# **Preliminary Root Causes Analysis of Failures of the Oroville Dam Gated Spillway**

R. G. Bea

Center for Catastrophic Risk Management  
University of California Berkeley  
April 17, 2017

DETAIL A

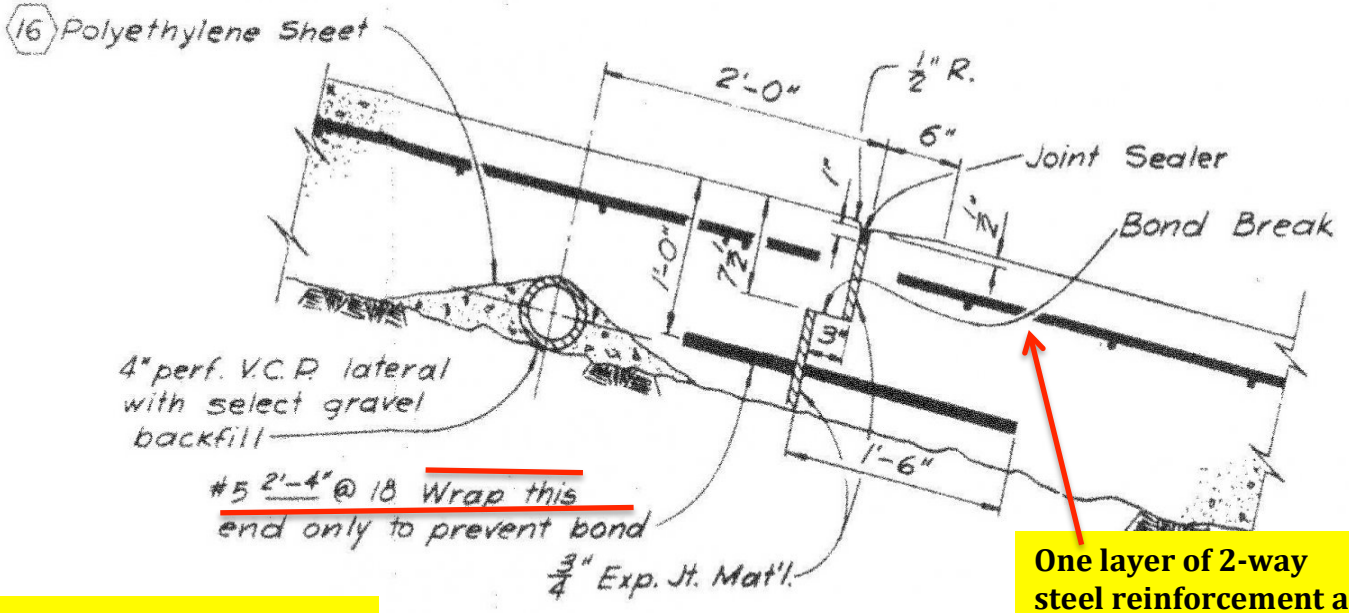
No 'continuous' steel across joint to prevent slab separation

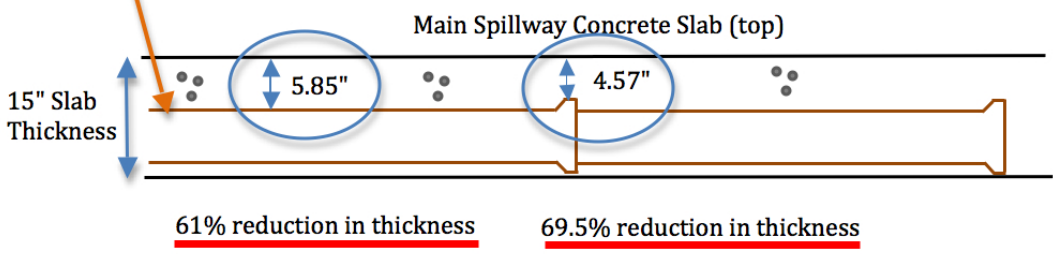
Spillway DESIGN Changed to 6" I.D. Drain Pipe: New dimensions should be very close to this table (6" D1, 7.87" D2, 10.43" D4)

**TYPICAL DETAIL**  
LONGITUDINAL INVERT CONTRACTION JOINT  
Scale: 1"=1'

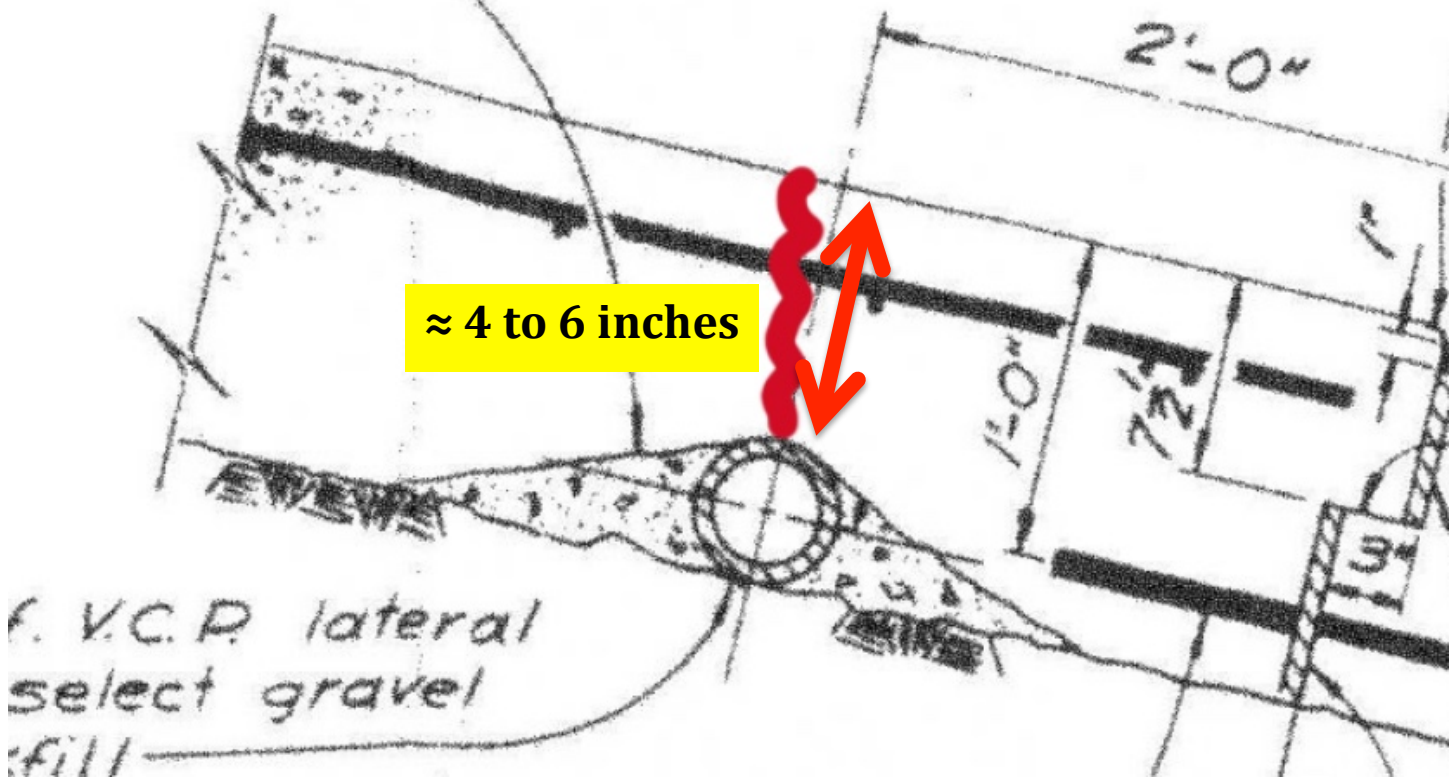
No steel reinforcement  
across slab joints to  
prevent separation

**TYPICAL DETAIL**  
SLAB EDGE EXPANSION JOINT  
Scale: 1"=1'

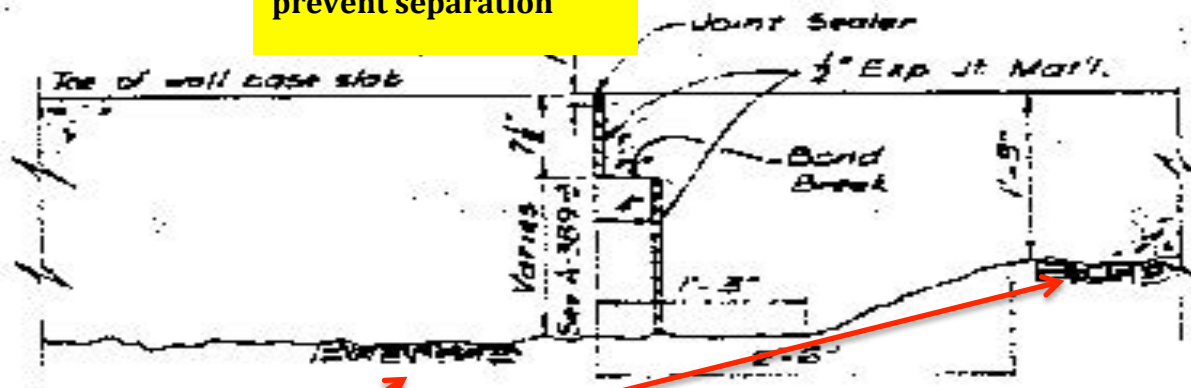
No steel reinforcement  
across slab joints to  
prevent separation

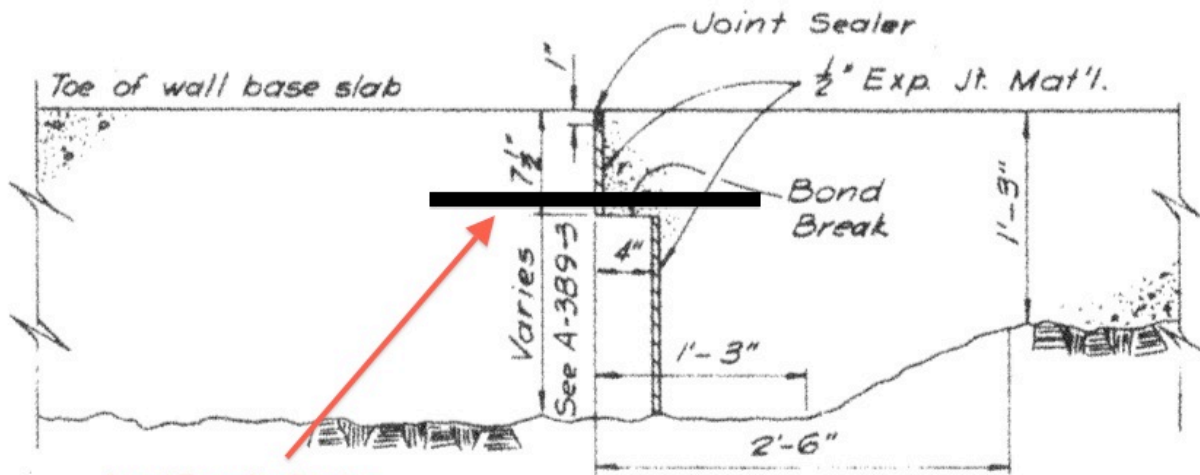
Chute base slabs  
designed to be  
constructed on 'rock'

Load Transfer Bar (as constructed - not shown in diagram)

**DETAIL B**  
ANCHOR BAR  
Scale: 1"=1'

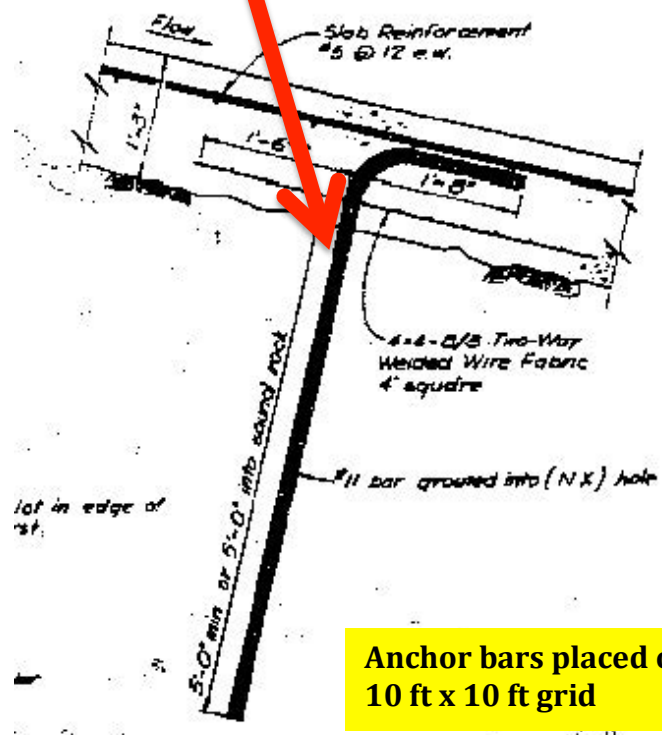
**One layer of 2-way steel reinforcement at top of chute slabs**

Steel reinforcement 'anchor' connecting spillway base slab to 'rock' - pulled away from slab

Anchor bars placed on 10 ft x 10 ft grid

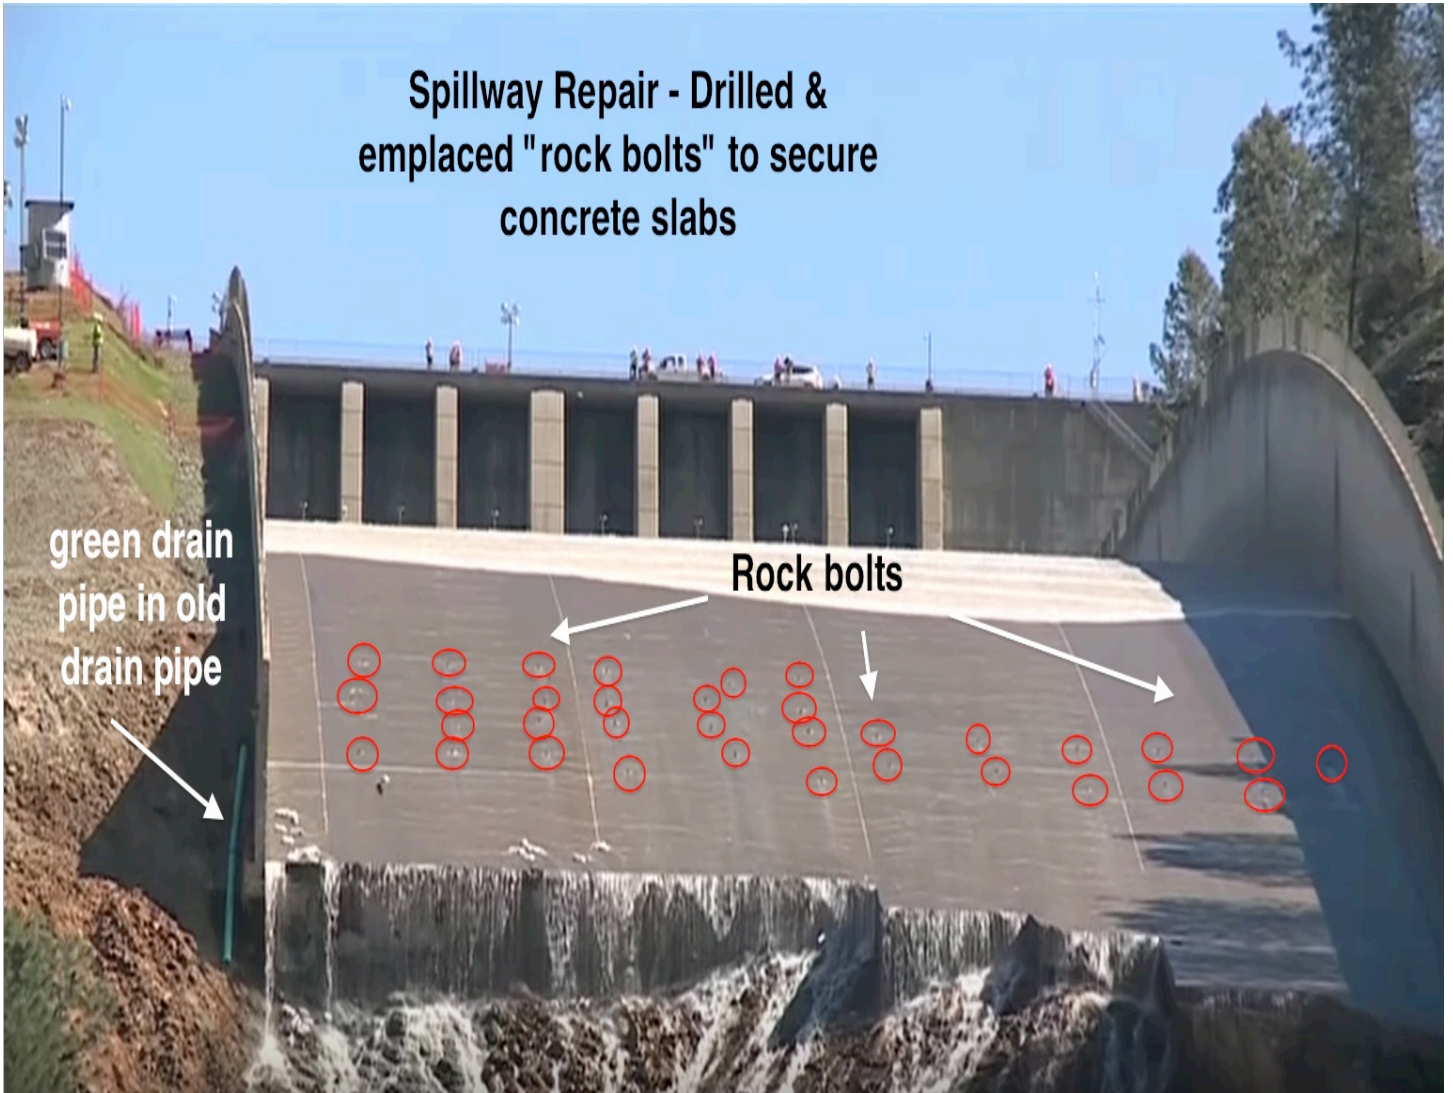
**No longitudinal reinforcement steel connecting spillway slabs to prevent separation**

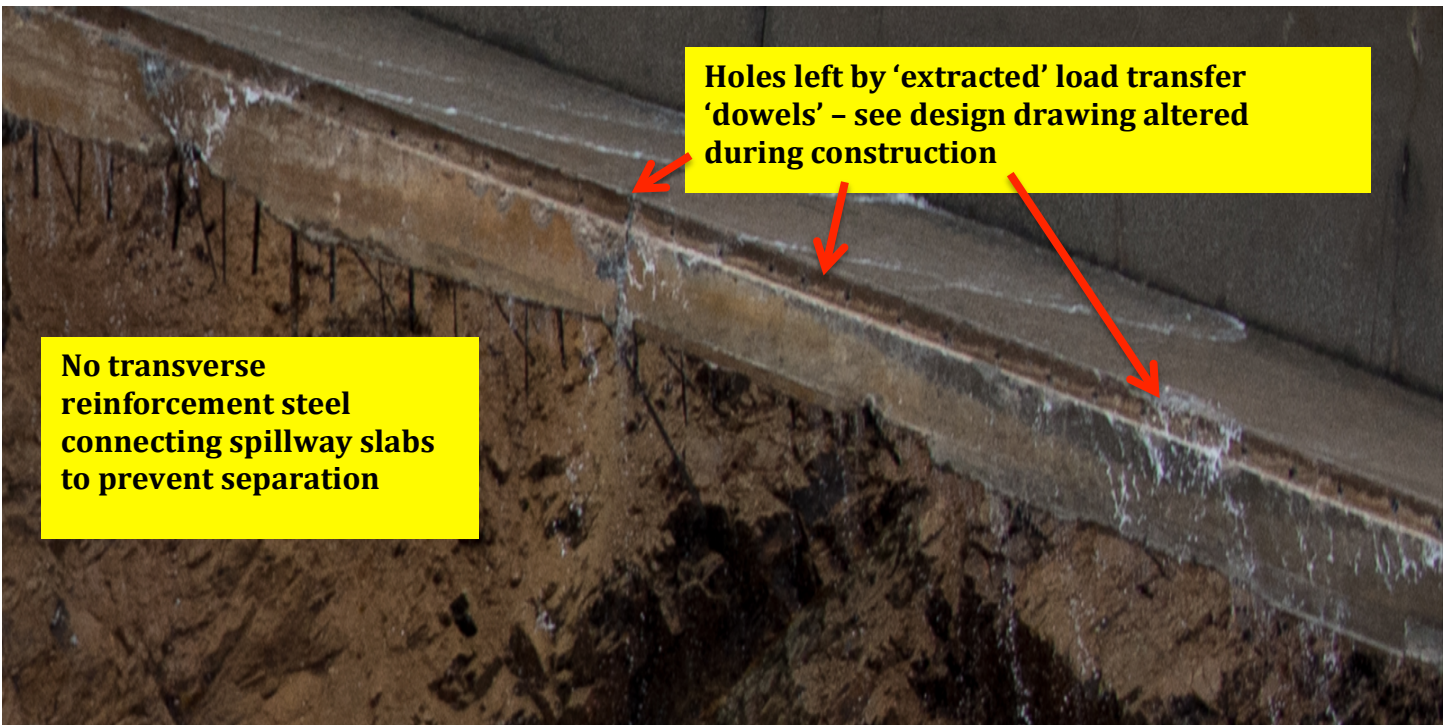
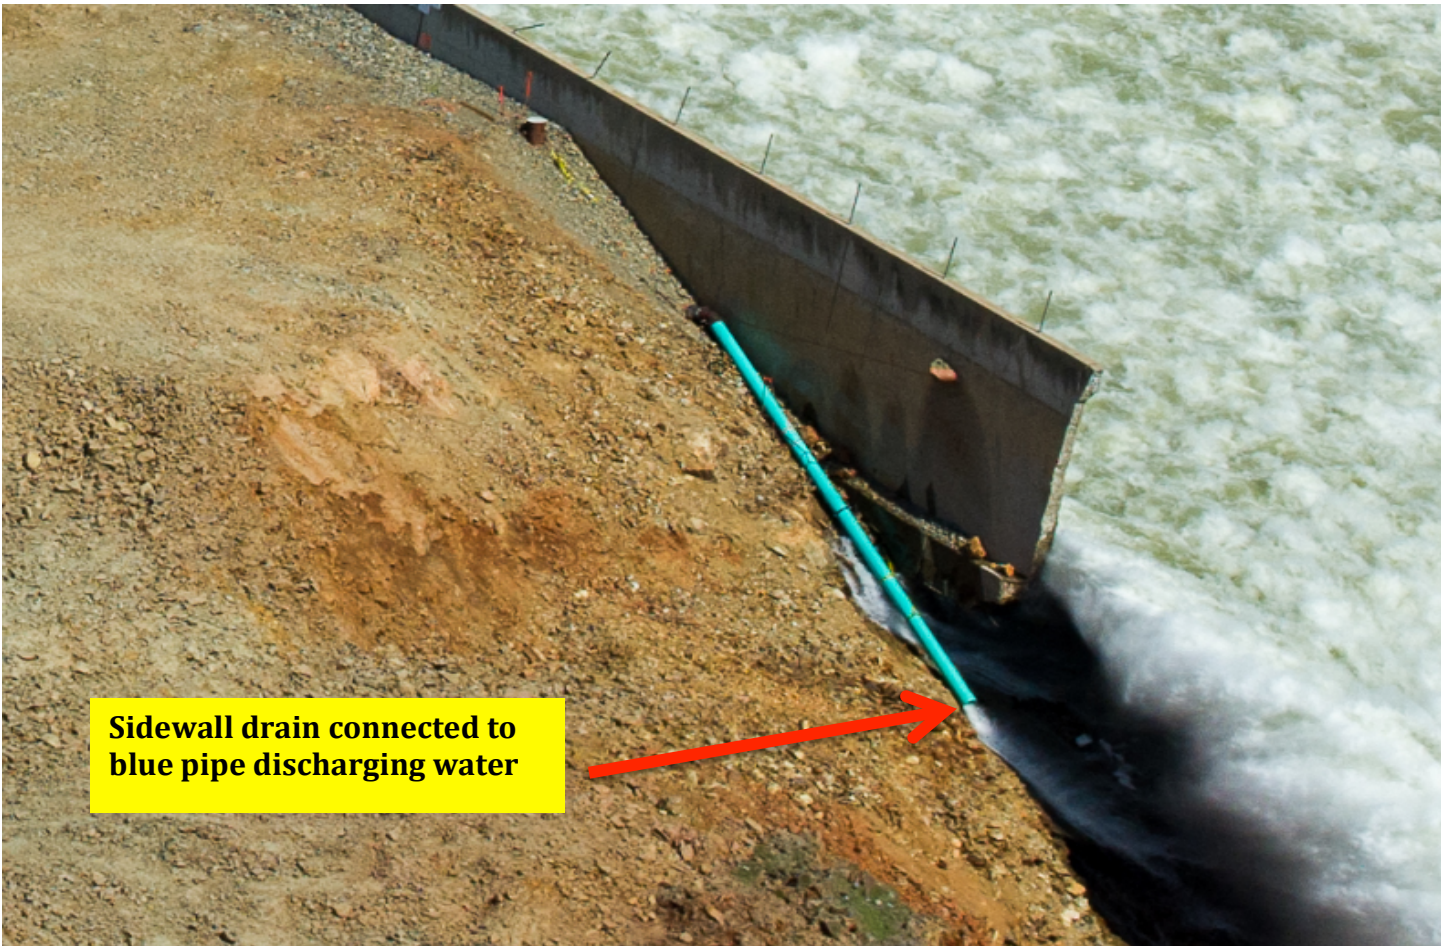
**No longitudinal reinforcement steel connecting spillway slabs**

**Sidewall drain connected to blue pipe discharging water**
